Subject: **MHI's Response to US-APWR DCD RAIs No. 939-6334 Revision 3 (SRP 03.07.01) and No. 940-6532 SRP (03.07.01)**

Response to Request for Additional Information No. 939-6334
Revision 3

US-APWR Design Certification

RAI NO.:	**NO. 939-6334, REVISION 3**
SRP SECTION:	**03.07.01 – Seismic Design Parameters**
APPLICATION SECTION:	**3.7.1**
DATE OF RAI ISSUE:	**06/12/12**

Figure 3, Comparison of Standard Deviation for Median Estimates for Strain Compatible Properties (shear-wave velocity, compressional-wave velocity, shear-wave damping, compressional-wave damping) Developed for 60 and 30 Realizations for 500 ft Deep Profile 560-500.

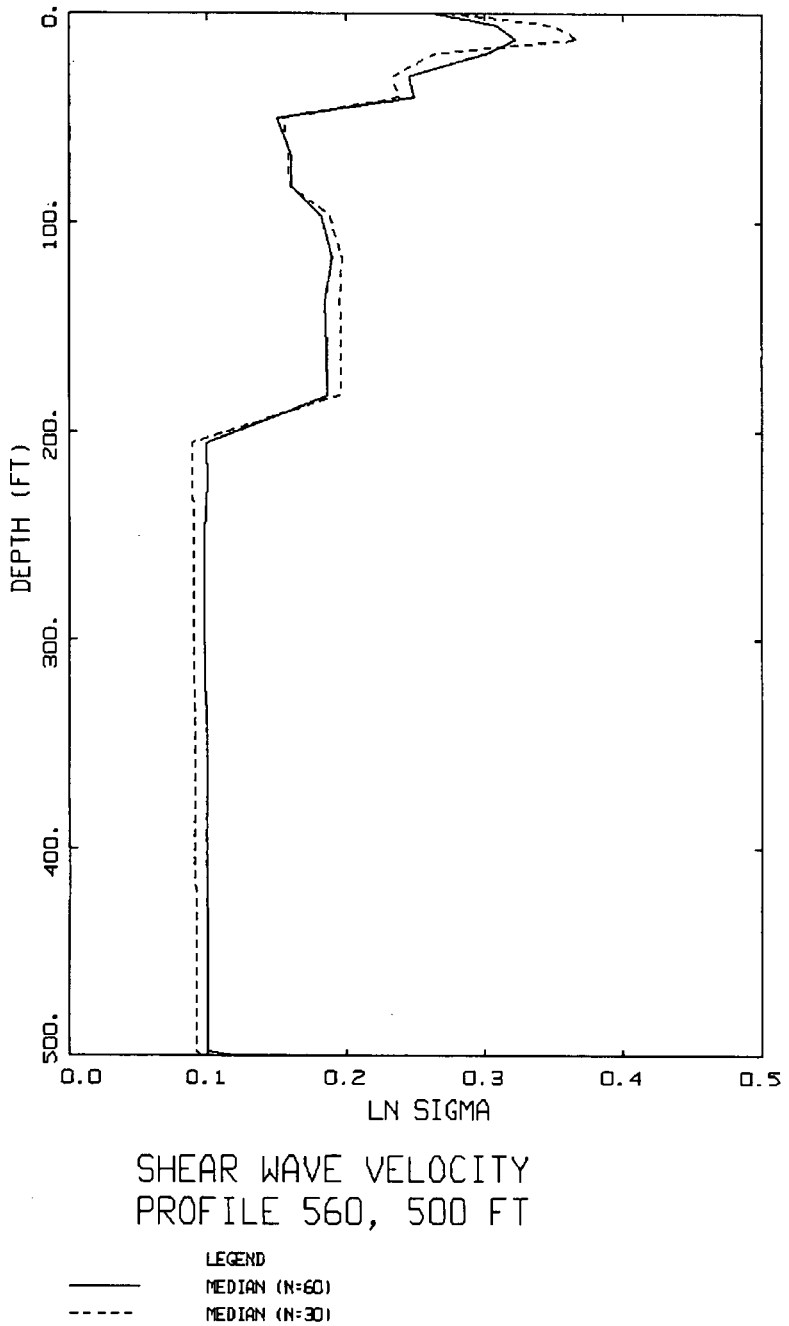
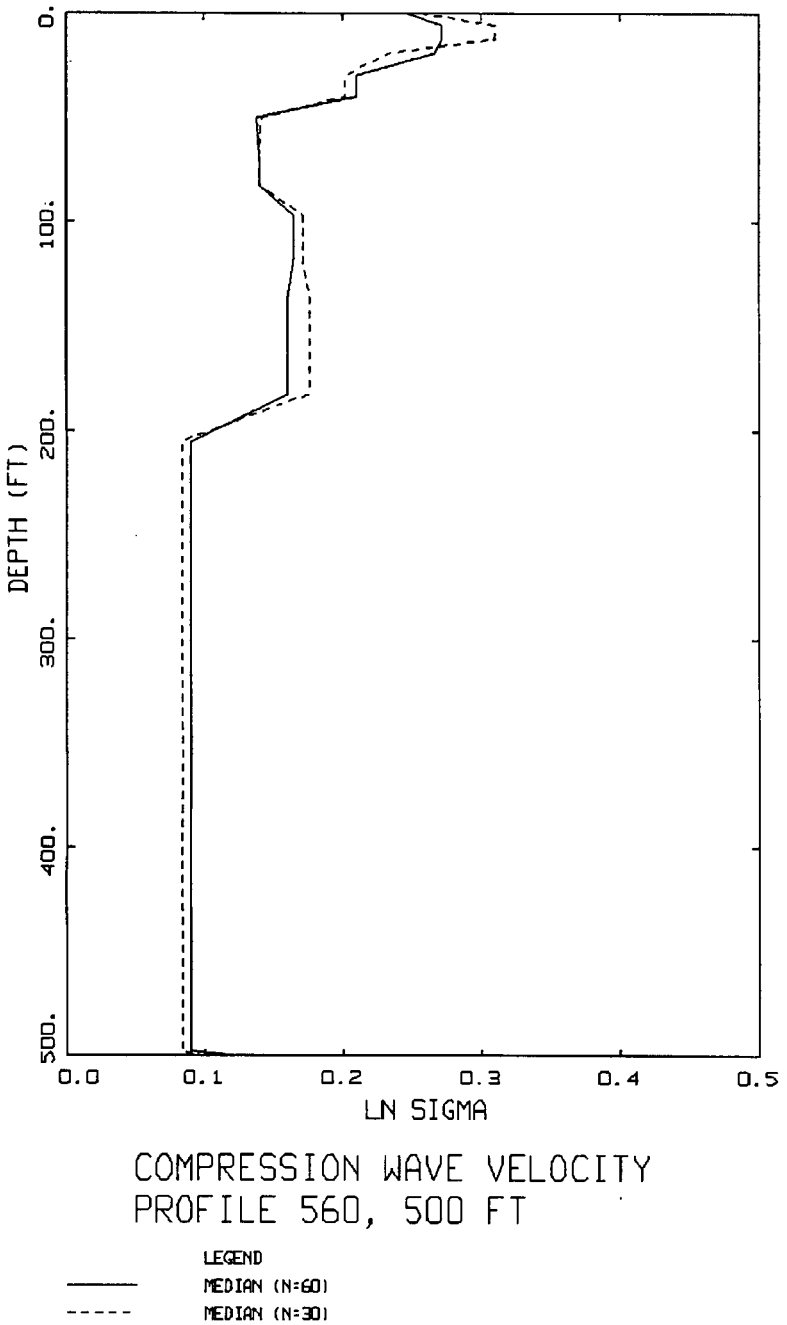
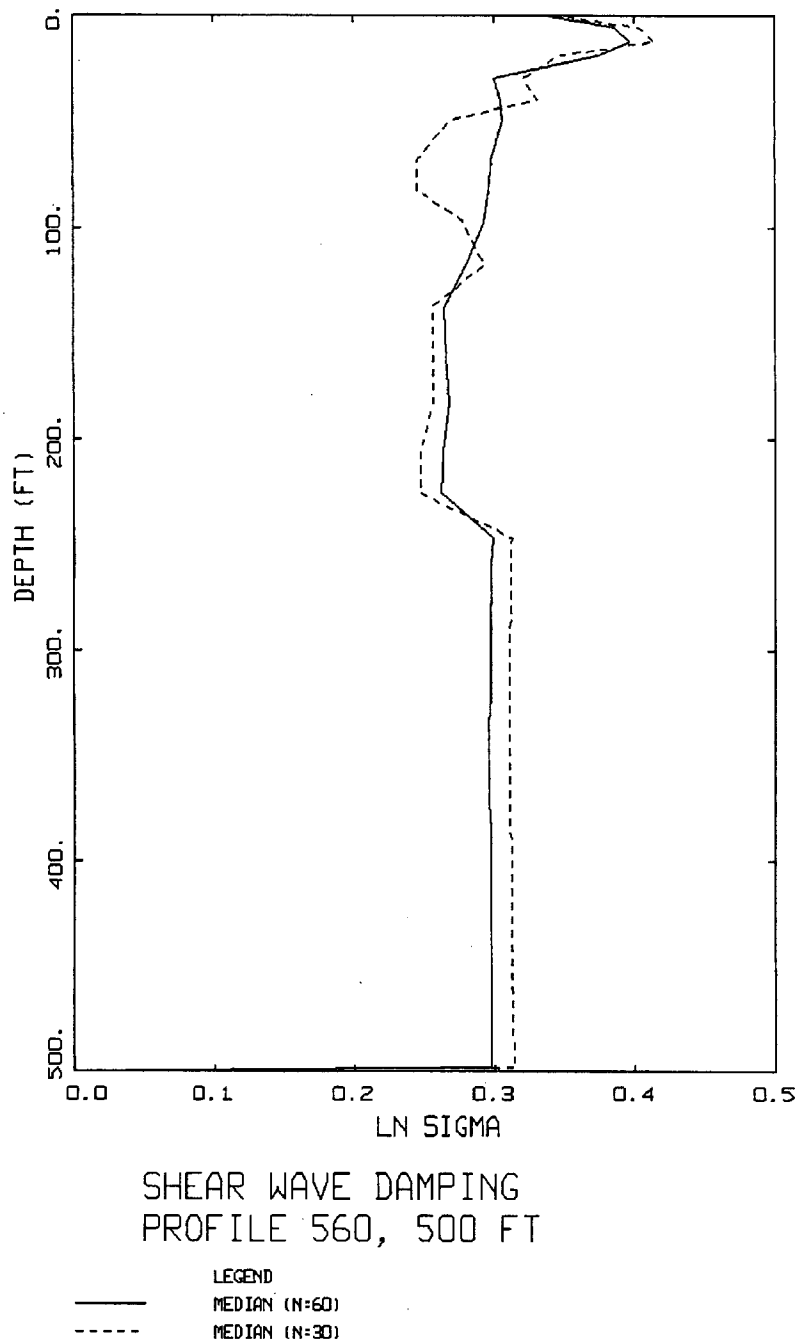
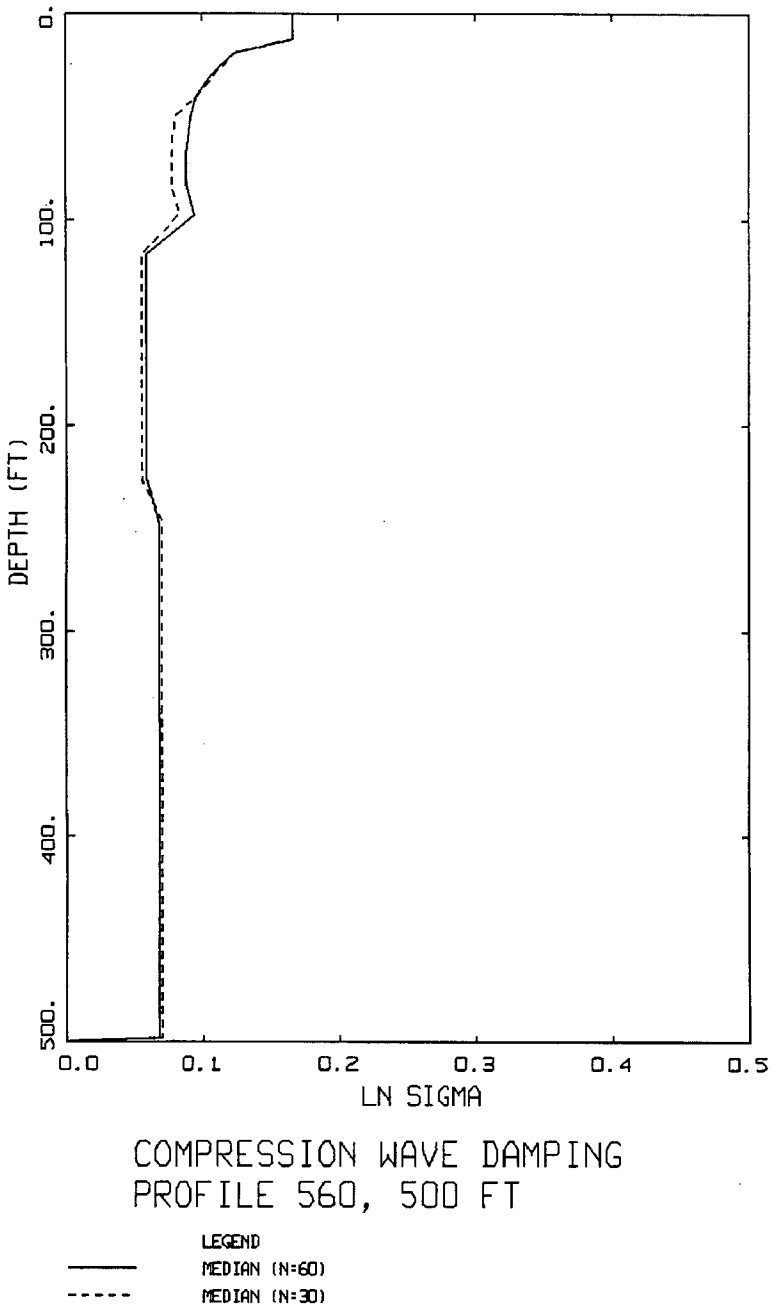
In its response to RAI 850-6002, Question No. 03.07.01-22, the applicant provides Table 1 which is taken from a source of standard statistical tables. Table 1 shows the sample size required for a given percent error in the standard deviation for a normal distribution, which the applicant purports to support their assertion that using 30 realizations in the analyses provides sufficient stable estimates of means and standard deviations. Further, the applicant states that increasing the sample size to 60 realizations reflects, at best, only an unnecessary and marginal improvement.

The staff considers that the evidence provided in Table 1 to be inadequate for supporting the applicant's argument. The staff is requesting that the applicant use actual data generated from the soil profiles in the US-APWR DCD; provide a table that shows conclusively the convergence as the number of realizations is increased; and provide the rationale to support the claim that 30 realizations instead of 60 realizations as specified in RG. 1.208 is adequate for the analyses.

MHI's position is that increasing the sample size from 30 to 60 reflects a marginal improvement to the accuracy of the strain compatible properties that are developed as median value of the results obtained from site response analyses of 30 realizations.. In order to illustrate the numerical stability in strain compatible properties between 30 and 60 realizations, Figure 1 compares median strain compatible property estimates computed for the two sample sizes for the deep (500 ft) generic profile 560 - 500. Figure 2 provides ratios of the property estimates, i.e., 30 realizations/60 realizations for all properties (shear-wave and compressional-wave velocities and corresponding damping). The maximum difference is about 5% and occurs over shallow and narrow depth ranges. Over the deeper portion of the profile, beyond a depth of about 150 ft, the difference is about 2% in shear-wave and compressional-wave velocity and about 4% in shear-wave damping.

A similar stability of 30 versus 60 realizations is provided for the standard deviation. Figure 3 is a plot, corresponding to the plot in Figure 1, for the Standard Deviations (sigmas) of the strain compatible properties. The percent difference between 30 verses 60 realizations is slightly larger

for sigma compared to the mean (Figures 1 and 2), as expected from standard statistical tables. These results support the position, based on standard statistical tables, that the difference in estimates of means and standard deviations is not significant between sample sizes of 30 and 60. The guidance in RG 1.208 for 60 realizations refers to the standard deviation of the simulated response spectra, which is not used in developing the strain compatible properties. The demonstration of stability of the strain compatible properties sigma estimates with respect to sample sizes of 30 versus 60 is offered to provide additional clarity in the process of developing the strain compatible properties.

As illustrated in the figures below, there are marginal improvements in increasing the sample size from 30 to 60. Therefore using 30 realizations is sufficient to provide reasonable estimates for the mean generic strain compatible properties used as input for the site-independent soil-structure interaction (SSI) analyses.
